ADDENDUM NO. 3

PETALUMA TURNING BASIN FLOAT, PILE, AND GANGWAY REPLACEMENT City Project Number C14402010

July 31, 2023

2 ROCK SOCKET DETAIL
S-502 SCALE: 1" = 3'

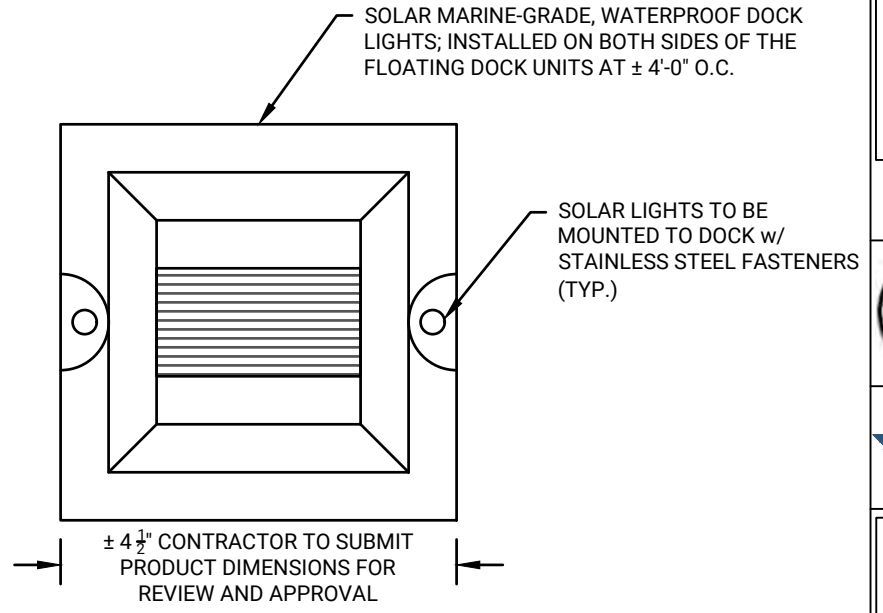
Q1: *If an alternative pre- drilling method can be developed by the contractor allowing a .5 inch wall pile to reach the original intended embedment of -35.3 ft., will the city accept this embedment in rock without grouting, in lieu of the -10ft with grout as shown in detail 2 of sheet S-502?*

Q2: *How are the drilling spoils to be dealt with if using the method shown on detail 2, sheet S-502 (where are they disposed? Does the anticipated permit allow for removing and disposing of predrilled spoils?)*

A1: The proposed pile size and drilling method is not in conformance with the Contract Documents. Should the Contractor wish to submit an alternate design, calculations shall be provided showing this meets the required pile strength and embedment, as specified within the Contract Documents. This shall be subject to the Engineers review and approval. Please refer to Section 01 50 00 SUBMITTALS AND SUBSTITUTIONS.

A2: Please refer to Sheet G-002 Selective Demolition & Disposal. It shall be the responsibility of the Contractor to properly dispose of all debris, including spoils. The Contractor shall submit a disposal certificate to the Engineer for review and approval.
